STATE OF NORTH CAROLINA  
DEPARTMENT OF TRANSPORTATION

July 27, 2011

SUBJECT: **Supplemental Information for Application for Section 404 Individual Permit and Section 401 Individual Water Quality Certification** for the proposed widening of R-2413C - US 220 south of the Haw River to the Intersection of US 220 and existing NC 68 in Guilford and Rockingham Counties, Division 7. State Project No. 6499008T, WBS Element No. 34429.1.1.

Permit Drawing 40  
 Sheet 22 of 17/2d/11  
**REVISED**

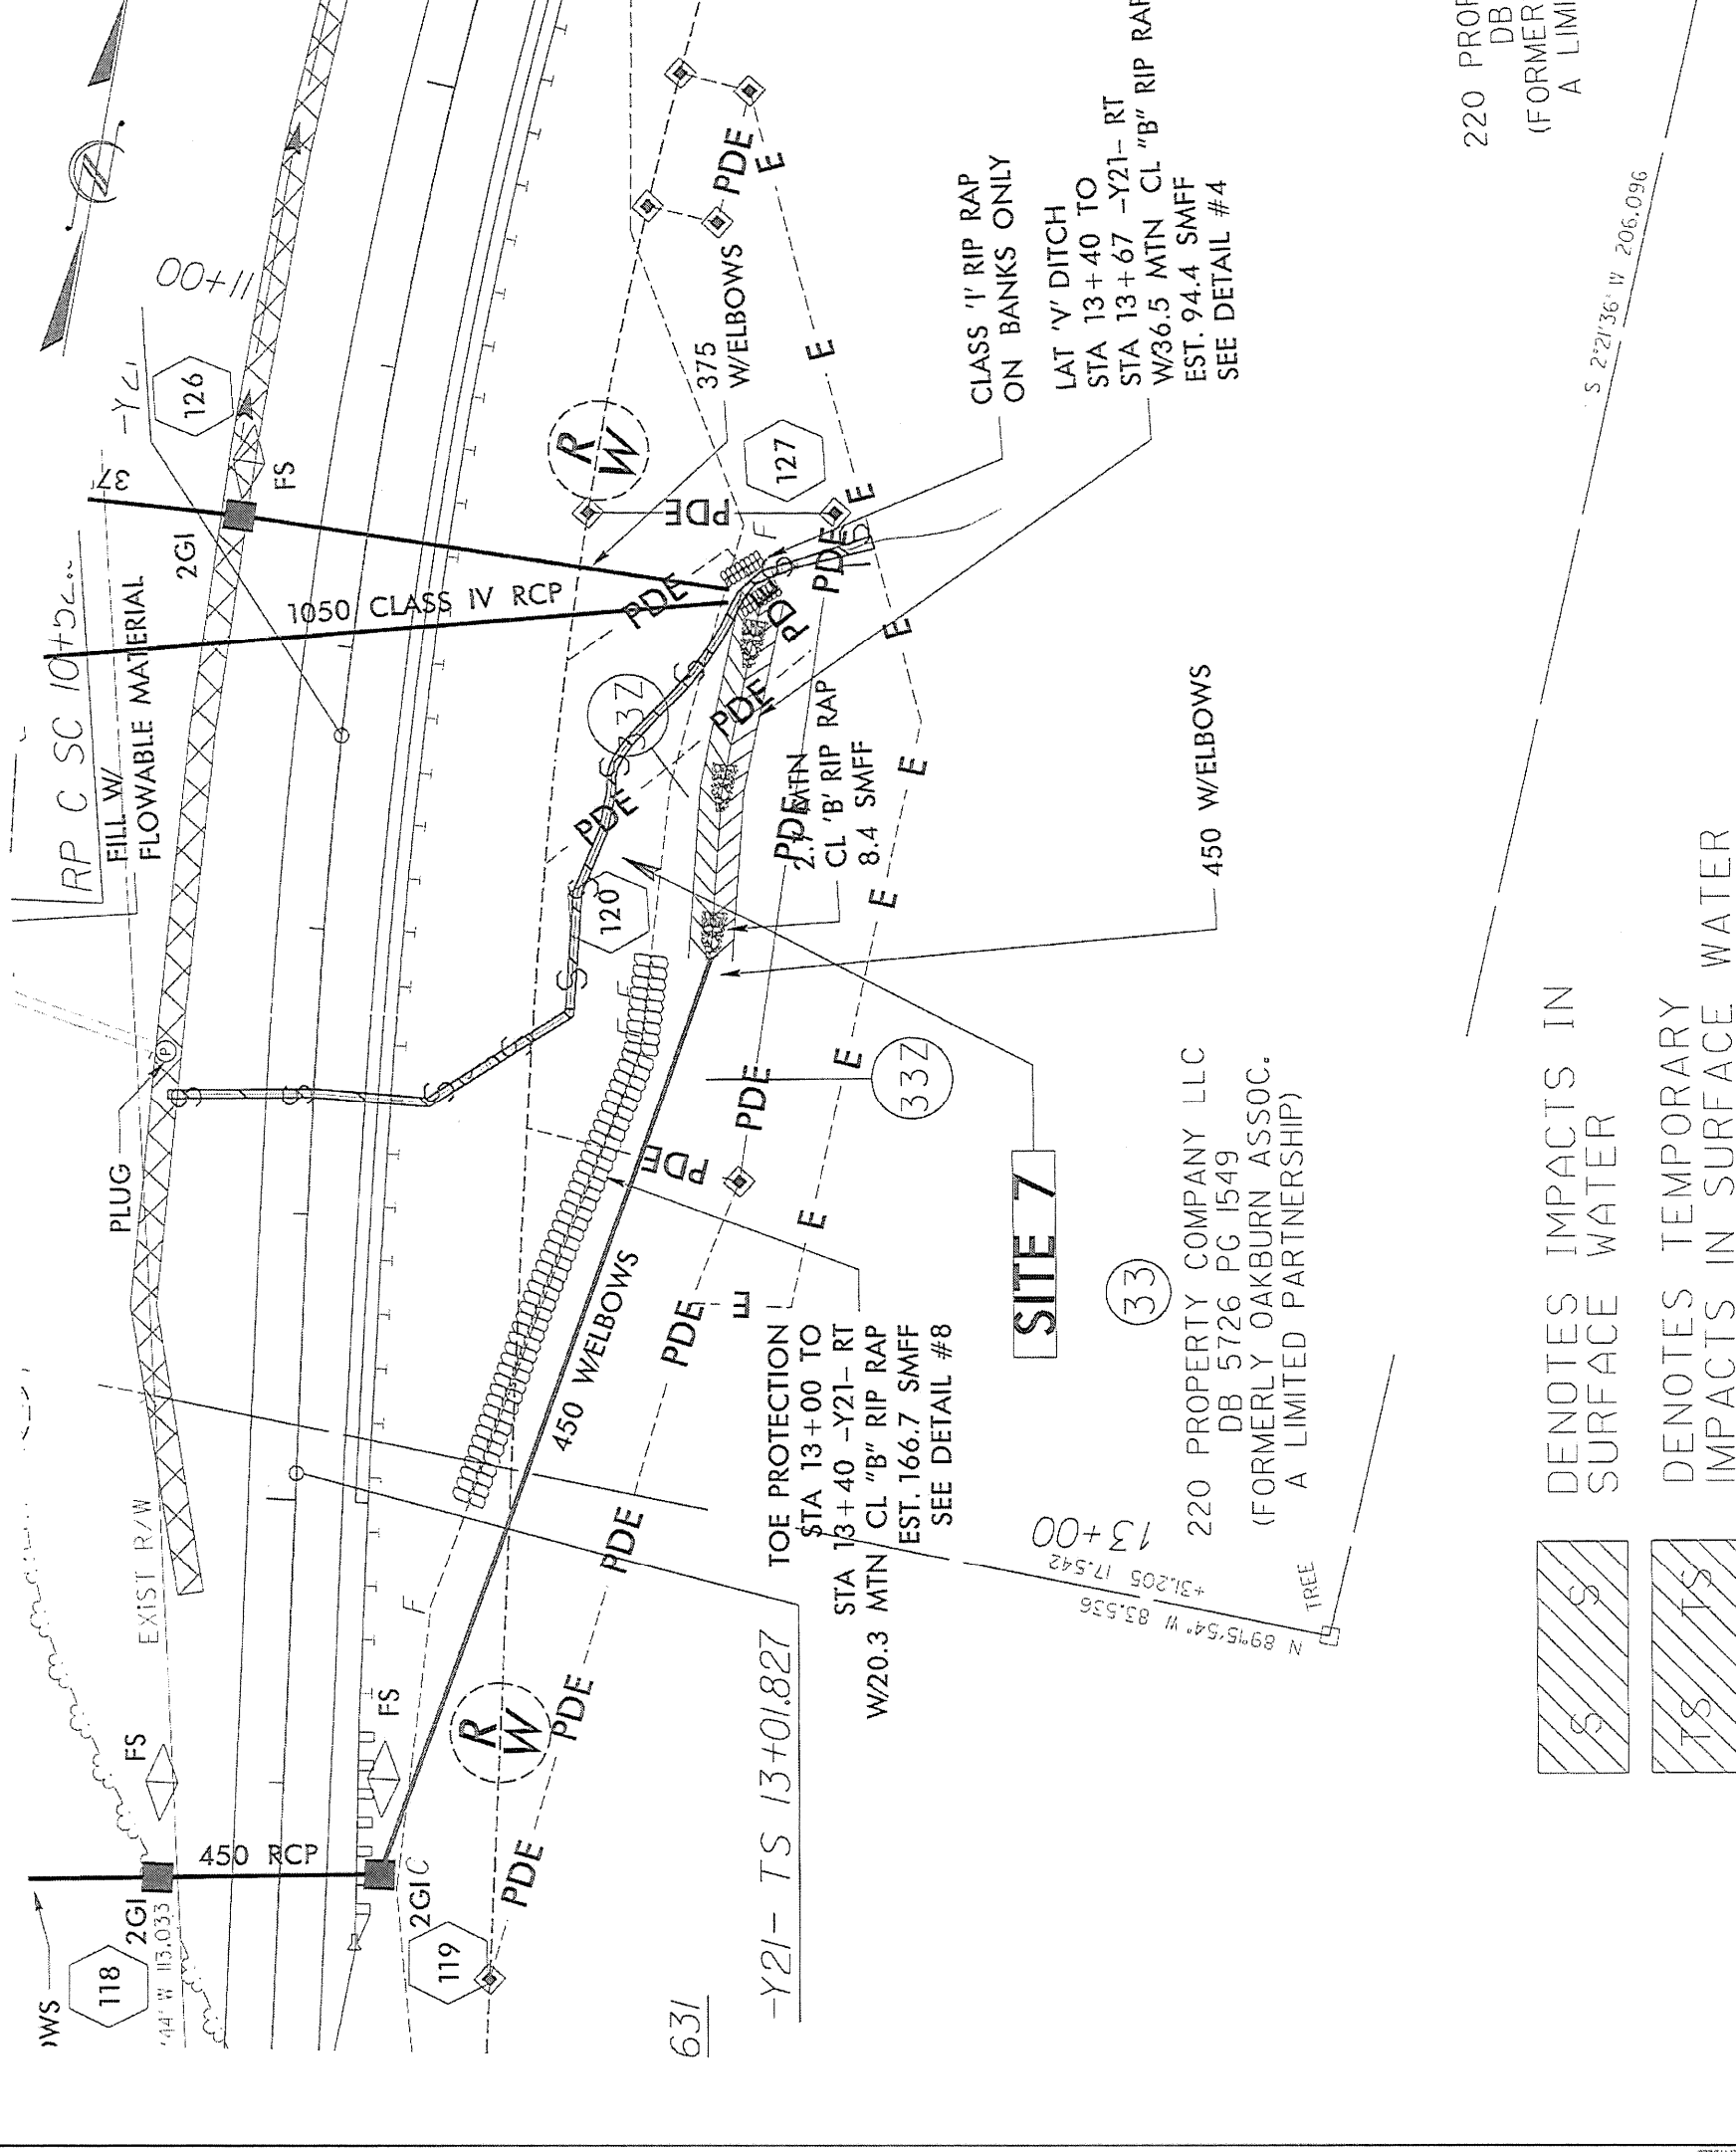
I'm working on the impact tables, and I noticed that temporary impacts have not been included for most of the permitted sites on R2413C. Can you make sure this is right? I'm not sure how they will dewater without temporary impacts.

*Site 7: Sheet 22 of 40*

Permit Drawing  
 Sheet 37 of 40  
 REVISED  
 7/20/11

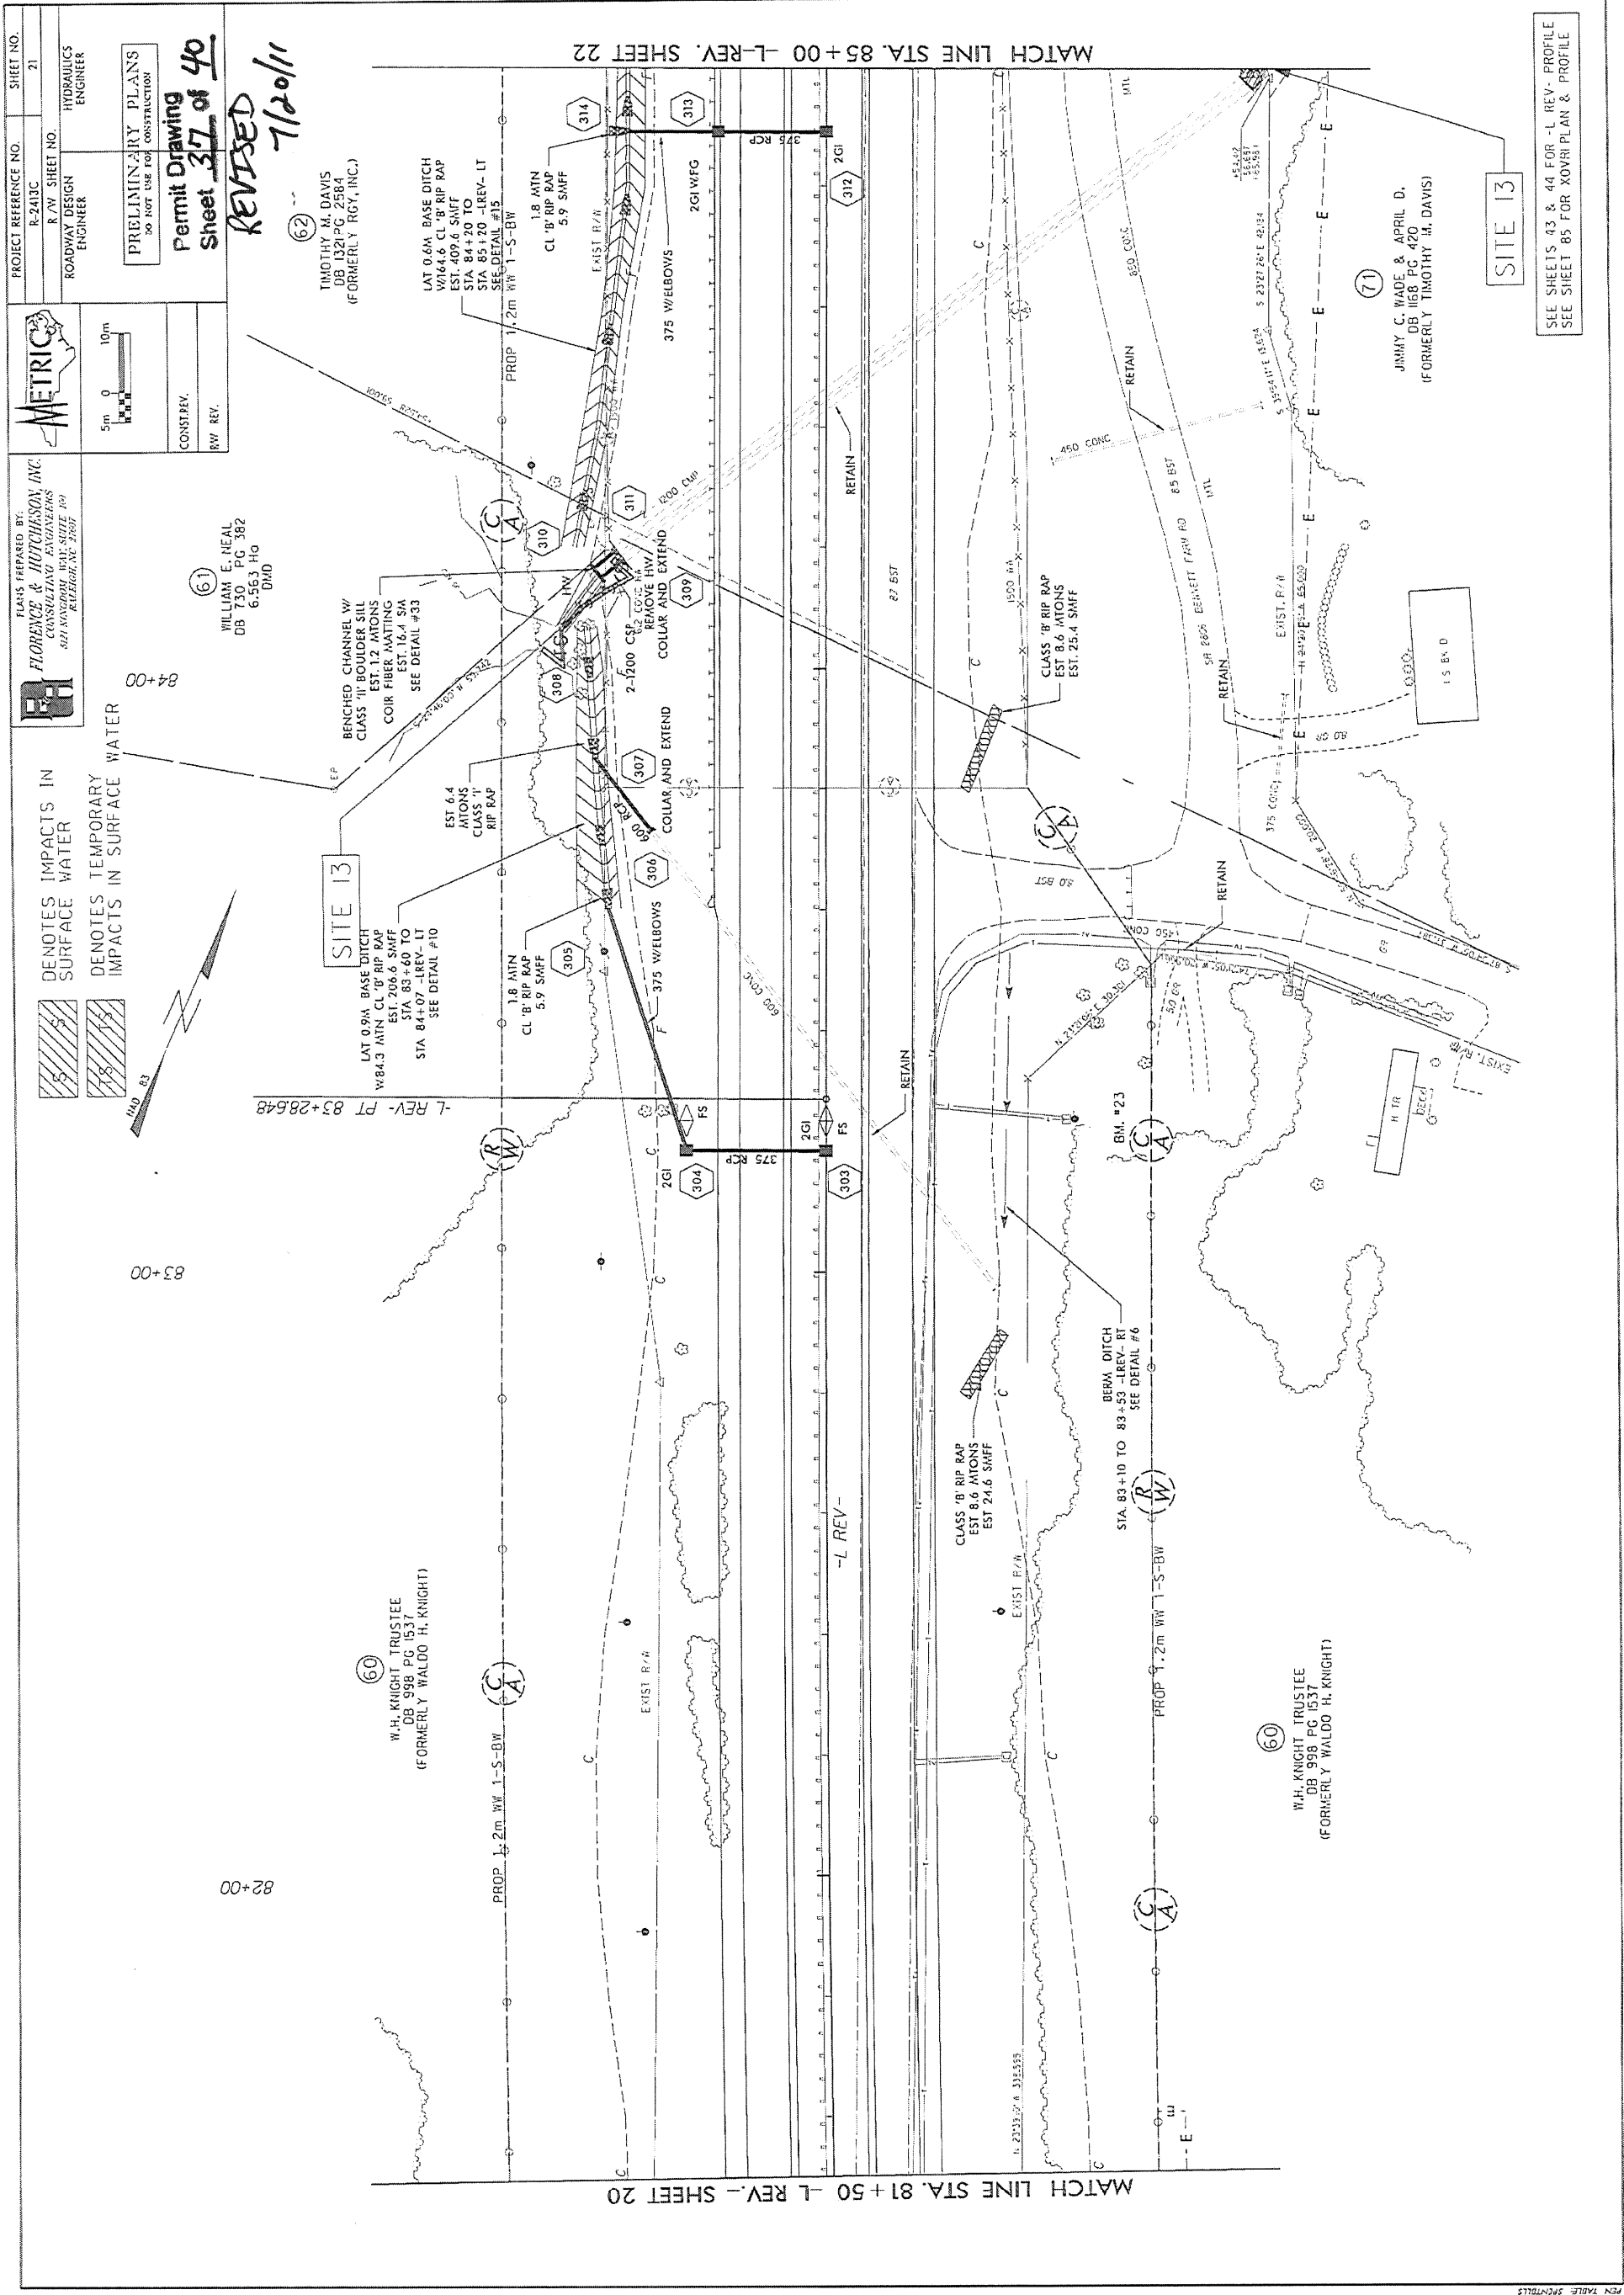
Site 13: I visited the site. Flow is currently going through both barrels. Just a couple feet upstream of the inlet the channel narrows to the width of a single pipe. The extension needs to have a sill installed, and have benches installed at the inlet and outlet.

*A sill has been specified along with channel benches for this stream crossing (see attached revised permit drawings Sheets 37 and 39 and Roadway detail drawing Sheet 2-G).*

*Site 13: Sheets 37 and 39*

# DETAIL #32 PREFORMED SCOUR HOLE

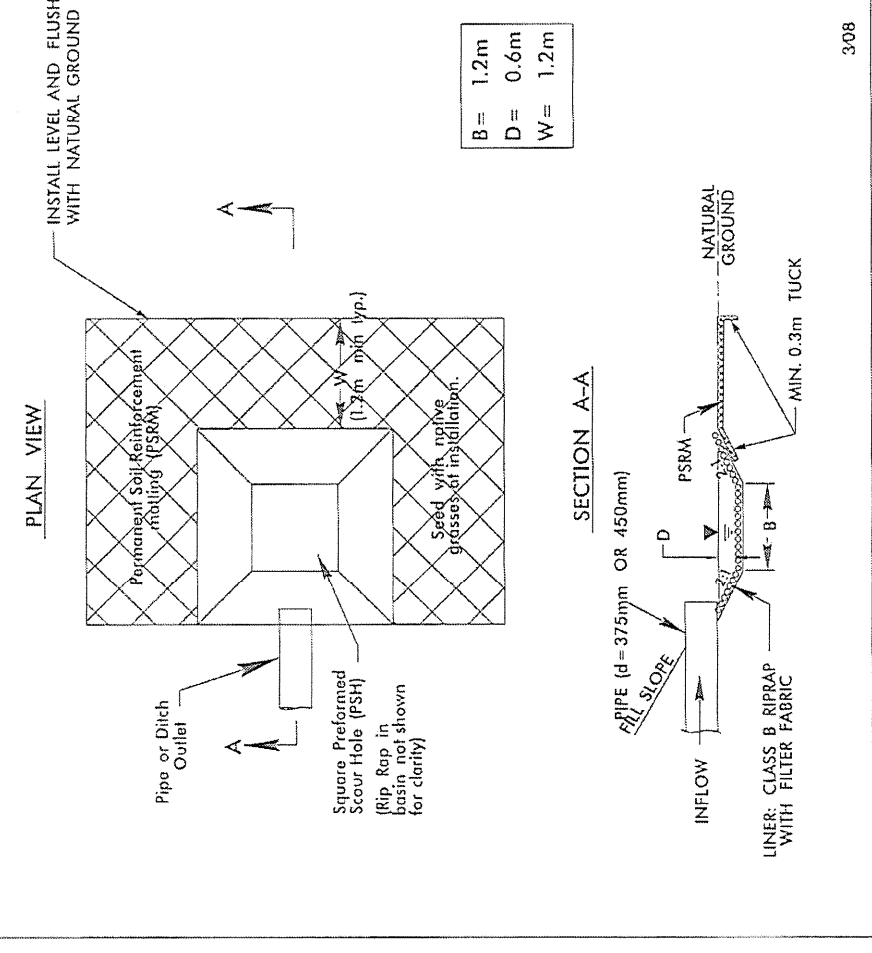
Can preformed scour holes (PFSH) be used at the following locations? If not, please explain why. The contour lines look like the area is relatively flat.

*NCDOT: PFSH's have been added in these locations*

*NCDOT: A PFSH has been added at this location.*
